RE: Lincoln Drive Median Access from Mockingbird Lane to the Eastern Town Limits

Subject: Lincoln Drive, Mockingbird Lane to Town of Paradise Valley (TOPV) Jurisdiction
Median Breaks and Access
Third Party Traffic Review Comments

FIGURE 5-3.35 DRIVEWAY SPACING

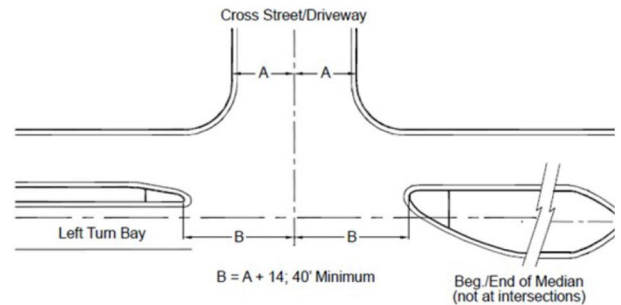
KH Comment 11: As shown in Option #1 exhibit, access improvements include closure of the existing eastern access on Smoke Tree Resort, a new Smoke Tree Resort access approximately 183 feet west of Lincoln Medical Plaza access, and the existing Smoke Tree Resort western access to remain as right in/right out. The proposed improvements result in the following spacing (centerline to centerline) of driveways:

- Approximately 134 feet from Quail Run to Smoke Tree Resort western right in/right out driveway;
- Approximately 183-feet from Smoke Tree Resort western right in/right out to the proposed Smoke Tree Resort full access median break;
- Approximately 183-feet from the proposed Smoke Tree Resort full access median break to the proposed Lincoln Medical Plaza full access median break; and
- Approximately 132 feet from the proposed Lincoln Medical Plaza full access median break to the eastern Lincoln Medical Plaza right in/right out access.

Per City of Scottsdale Design Standards & Policy Manual (2018), the minimum driveway spacing is presented in the Figure on the following page. It should be noted that a major arterial in the City of Scottsdale is configured as a six-lane divided roadway. Lincoln Drive is a four-lane divided roadway, so a minor arterial classification was utilized to determine the minimum spacing required (250 feet) on Lincoln Drive.

Based on the results, Kimley-Horn recommends the western Smoke Tree Resort driveway be closed to achieve the minimum spacing from Quail Run.

Figure 4.2 Process for Selecting Average Rate or Equation
in Trip Generation Manual Data

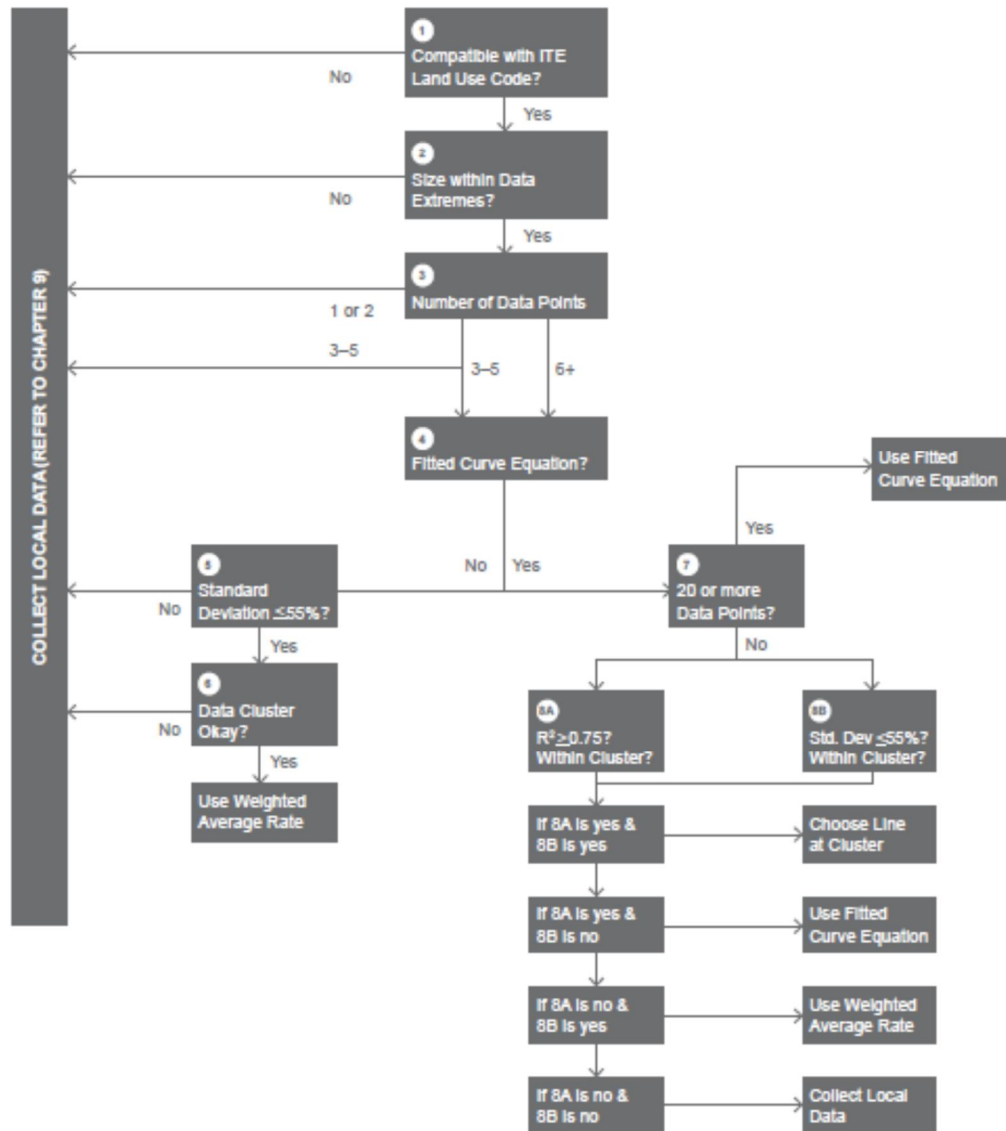
KH Comments 4: Smoke Tree Resort utilized equations as opposed to average rates. KHA went through the ITE Trip Generation Handbook process presented in Figure 4.2 assuming proposed number of units for resort hotel (LUC 330). The results of this process are presented below and KH redlines provided in **Appendix 1**.

- The number of rooms is way out of range of the data extremes; the lowest number of rooms in the manual is roughly 370 compared to the 132 that are proposed
- If you follow the equation, which happens to be a straight line and not a logarithmic function, then 132 rooms will generate a very low number of trips
- The number of data points is equal to 6
- The R2 value is close to the required 0.75, so you could argue it either way
- The standard deviation is less than 55% of the average rate

Because the rooms are not within the data extremes and the R2 value is less than 0.75, we recommend the weighted rates be used. Using the rates as opposed to the equation results in double the trips being generated in the AM peak hour.

Response to Comment 4: CivTech has updated the trip generation rates to reflect a blended rate between LUC 310 and 330 as discussed in response to comment #3. The trip generation calculations were also revised to reflect 150 rooms, 30 residential units, and 3500 square foot quality restaurant. The revised trip generation calculations and approach were considered acceptable. The revised trip generation calculations, based on 150 rooms, 30 residential units, and 3500 square foot quality restaurant, are provided in **Appendix 2**.

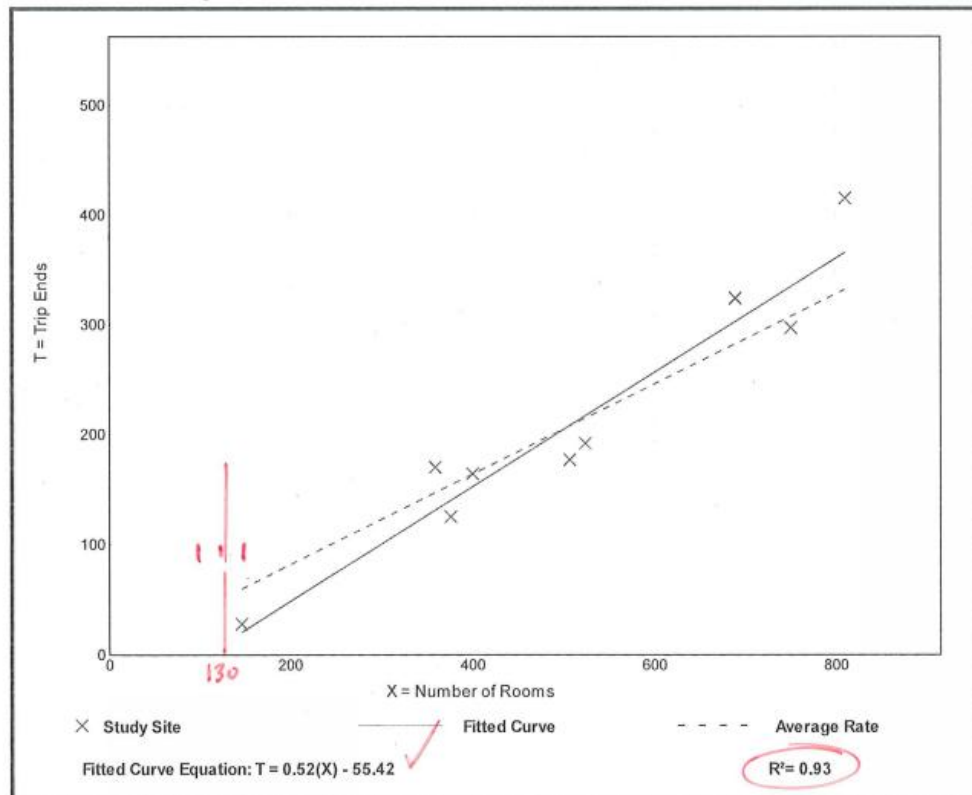
- The number of rooms is just outside of the data extremes
- The number of data points is greater than 6
- The R2 value is well above the required 0.75
- The standard deviation is less than 55% of the average rate

Because the number of data points and the R2 value are high enough and the standard deviation requirement is met, the use of the equation during the PM peak is appropriate.

Kimley-Horn Comments on
CivTech Access Assessment Option 1 through 3

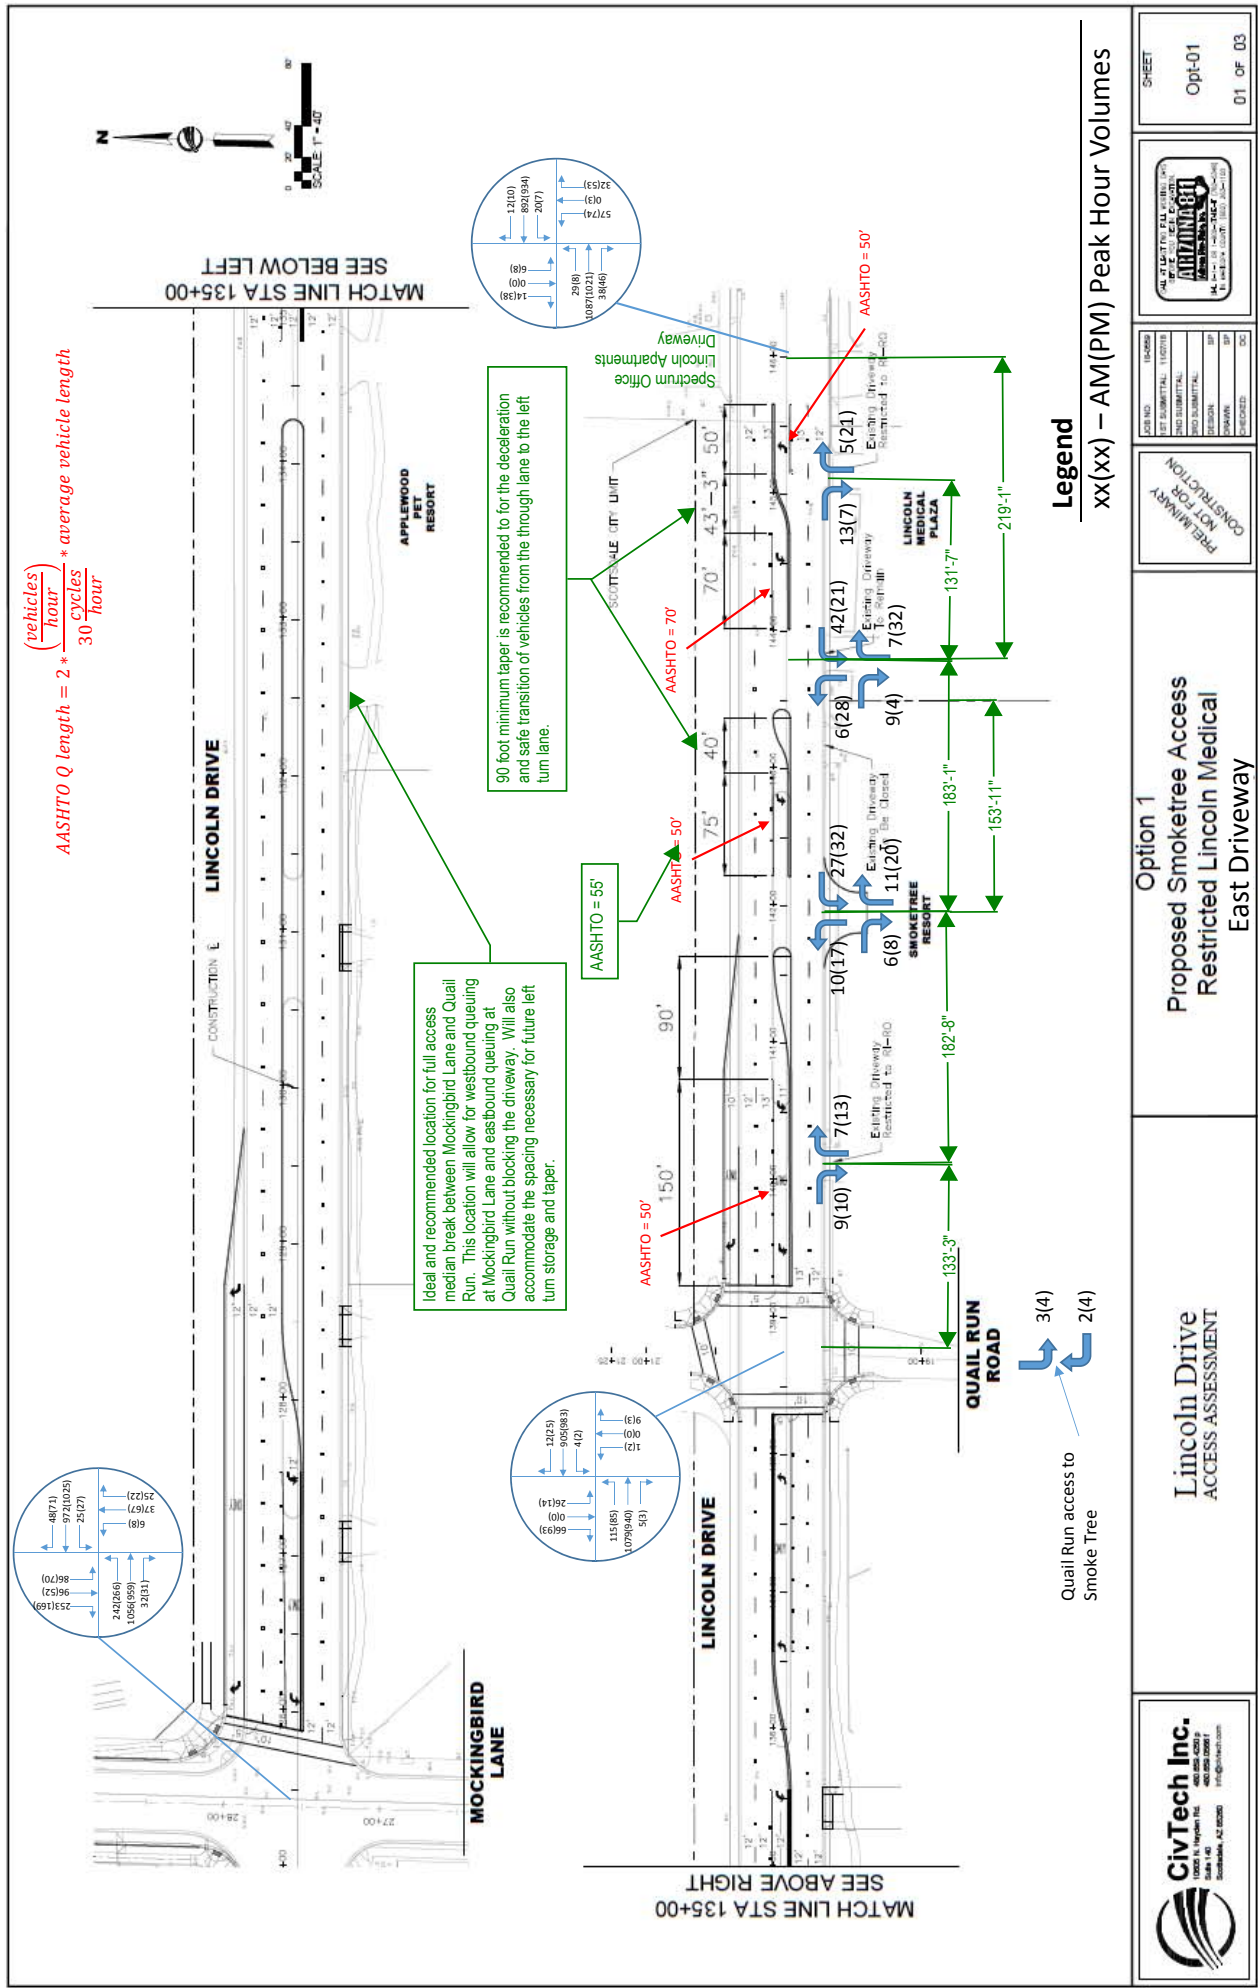
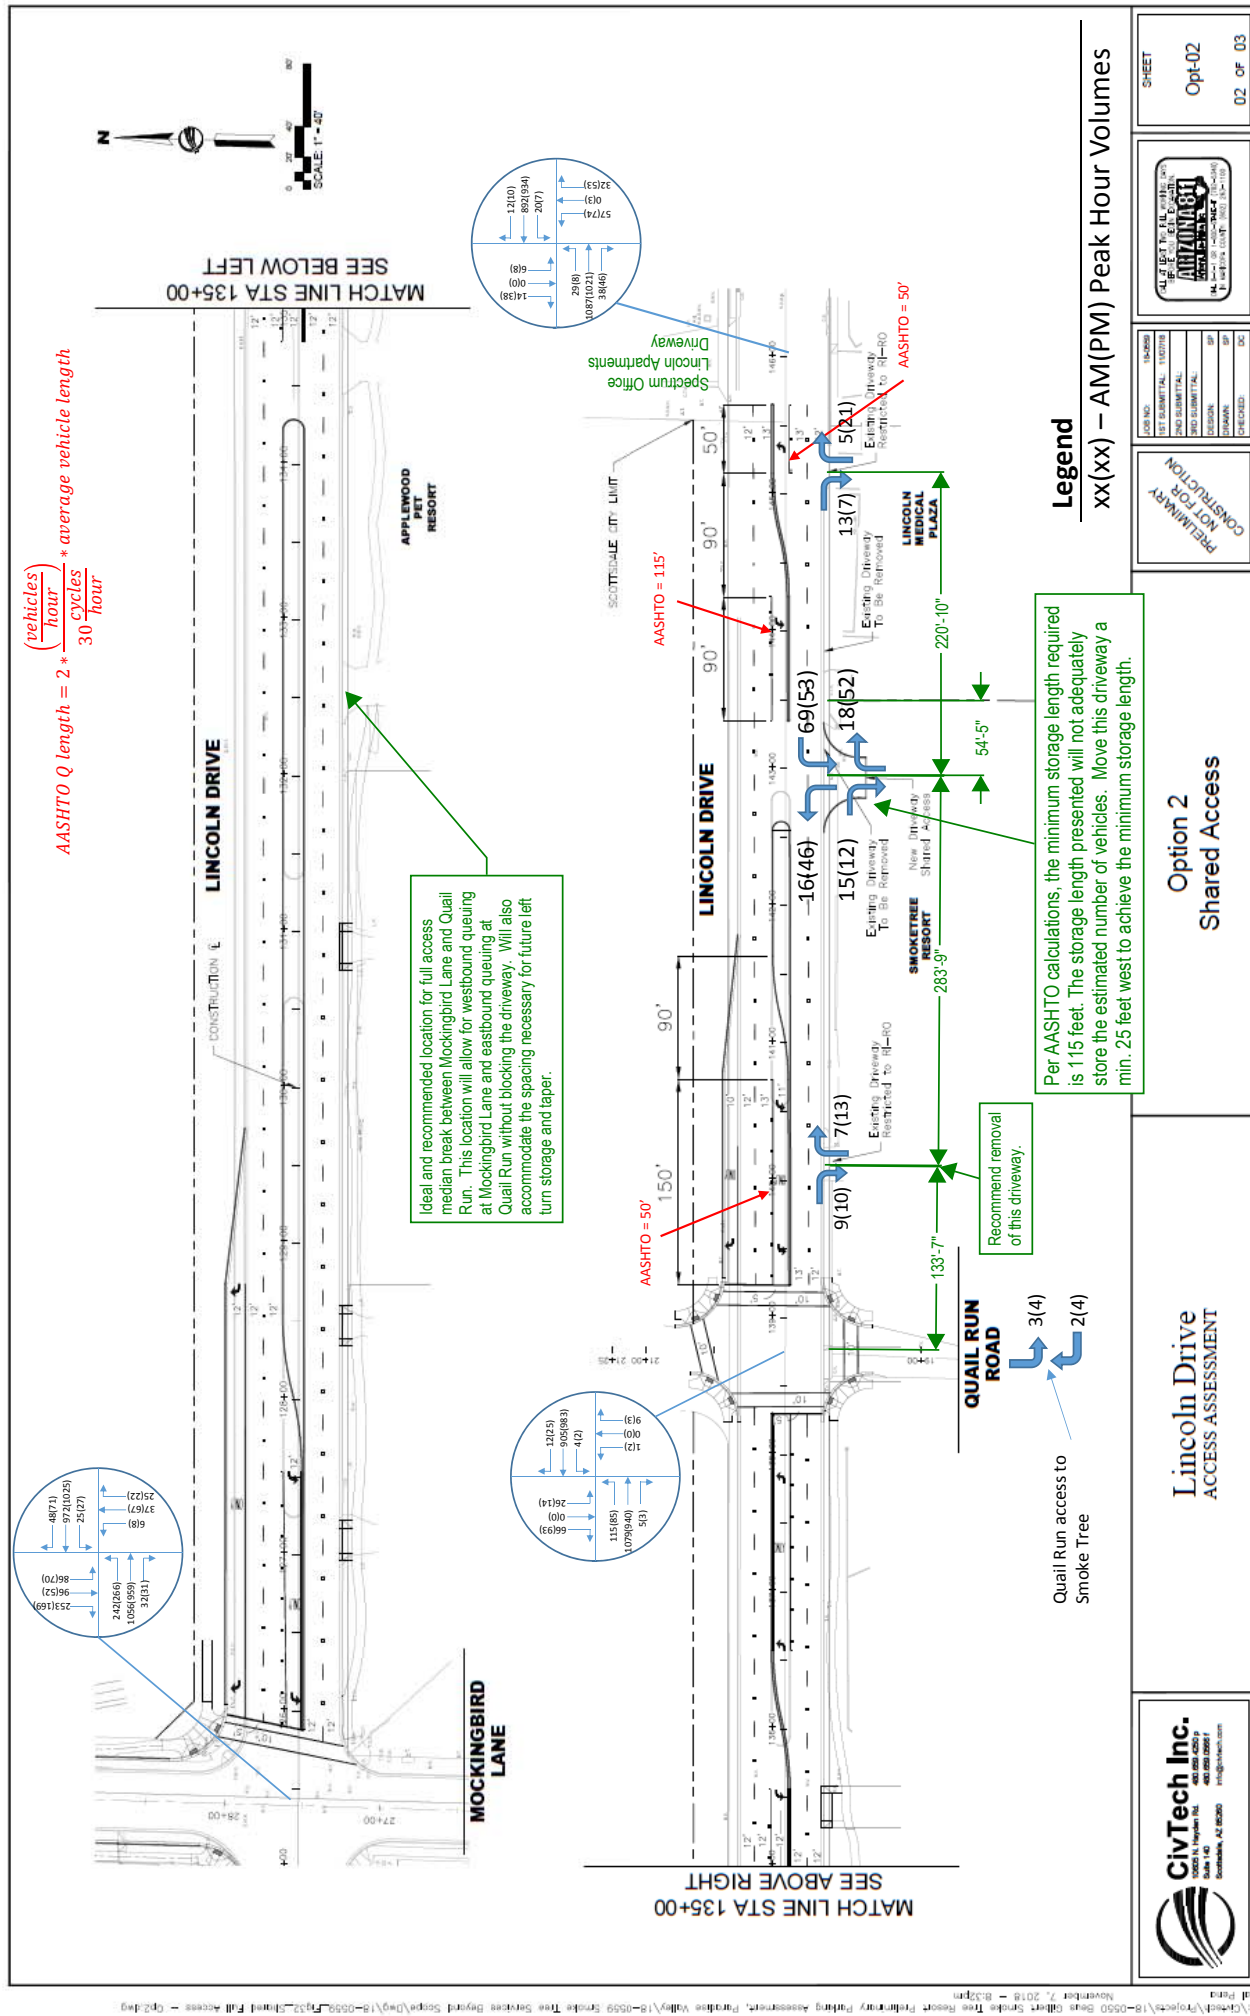
KH Comment 9: *This comment applies to all CivTech exhibits prepared. Traffic volumes were not available for the driveways between Mockingbird Lane and Quail Run. In the absence of these volumes, AASHTO A Policy on Geometric Design of Highways and Street (2011), TRB Access Control Manual (2nd Edition), City of Scottsdale Design Standards & Policy Manual (2018), and engineering judgement was utilized to comment and make recommendations for full median break recommendations on Lincoln Drive between Mockingbird Lane and Quail Run.*

KH Comment 10: Storage length at Spectrum Office Driveway/AJ Driveway calculation ((29 vph x 25 feet x2)/30) is 48 feet. Per AASHTO, the minimum storage length is 50 feet. Exhibit illustrates a minimum of 50 foot being provided. This is considered acceptable.

KH Comment 12: The storage length shown in Option #1 exhibit for Lincoln Medical Plaza is 70 feet. Per AASHTO calculations, storage length should be no less than 70 feet to adequately store the estimated number of vehicles generated by Lincoln Medical Plaza. This is considered acceptable. The storage length for the Smoke Tree Resort eastern driveway is 75 feet. Per AASHTO calculations, storage length should be no less than 55 feet to adequately store the estimated number of vehicles generated by the Smoke Tree Resort. This is considered acceptable.

KH Comment 13: As shown in Option 1 exhibit prepared by CivTech, opening bay tapers are 40 feet at Smoke Tree Resort and 43-3" feet at Lincoln Medical Plaza. KH recommends that no less than a 90-foot opening taper be utilized to safely traverse traffic from the through lane to the left turn lane on Lincoln Drive, per the criteria and discussion on Page 4, 5, and 6 of this document. Kimley-Horn recommends the median be extended and access points to Lincoln Medical Plaza be restricted to right in/right out only movements for two reasons:

KH Comment 14: As shown in Option #2 exhibit, access improvements include closure of the western Lincoln Medical Plaza access, a new shared access for the Smoke Tree Resort / Lincoln Medical Plaza approximately 55 feet from the shared Smoke Tree Resort / Lincoln Medical Plaza parcel line, and right in/right out to all other access points between Quail Run and TOPV jurisdictional boundary line. The proposed improvements in this option result in the following spacing (centerline to centerline) of driveways:

KH Comment 15: As shown in Option 2 exhibit prepared by CivTech, opening bay taper to the shared Smoke Tree Resort and Lincoln Medical Plaza is 90 feet. This is considered adequate.

KH Comment 16: The storage length shown in Option #2 exhibit for the shared Smoke Tree Resort/Lincoln Medical Plaza access is proposed at 90 feet. Per AASHTO calculations, storage length should be no less than 115 feet to adequately store the estimated number of vehicles generated by

KH Comment 17: *As shown in Option #3 exhibit, all existing driveways between Quail Run and eastern Lincoln Medical Plaza access points, will remain and be restricted to right in/right out only. This results in the following spacing (centerline to centerline) between the existing driveways:*

KH Comment 18: *This option does provide the safest option by removing the conflict points that would occur with left in/left out maneuvers. It should be noted that Lincoln Drive does not provide enough pavement width necessary to safely make U-turn maneuvers. Providing an access point that is located to safely transition and adequately store the estimated left turn volumes will reduce the need for U-turn maneuvers. Allowing shared access between the Smoke Tree Resort and Lincoln Medical Plaza parcels would remove the need for any U-turn maneuvers. For this option, should it be determined that shared access will not be provided, Kimley-Horn recommends U-turns be restricted.*

Per City of Scottsdale Design Standards & Policy Manual (2018), the minimum driveway spacing is presented the minimum spacing required (250 feet) on Lincoln Drive. Kimley-Horn recommends the western Smoke Tree Resort driveway be closed to achieve the minimum spacing from Quail Run.

Smoke Tree Resort and Lincoln Medical Plaza. For this option, the shared access should move a minimum of 25 feet west of the location shown in the CivTech exhibit to accommodate the minimum storage length necessary to adequately store the estimated left turn volumes without spilling back into Lincoln Drive through lanes. This would result in placing the shared driveway a minimum of 80 feet from the Smoke Tree resort/Lincoln Medical Plaza parcel line.

Per City of Scottsdale Design Standards & Policy Manual (2018), the minimum driveway spacing is presented the minimum spacing required (250 feet) on Lincoln Drive. Kimley-Horn recommends the western Smoke Tree Resort driveway be closed to achieve the minimum spacing from Quail Run. We further recommend that with the improvements to both Smoke Tree Resort and Lincoln Medical Plaza that the driveways be improved to achieve the minimum spacing.
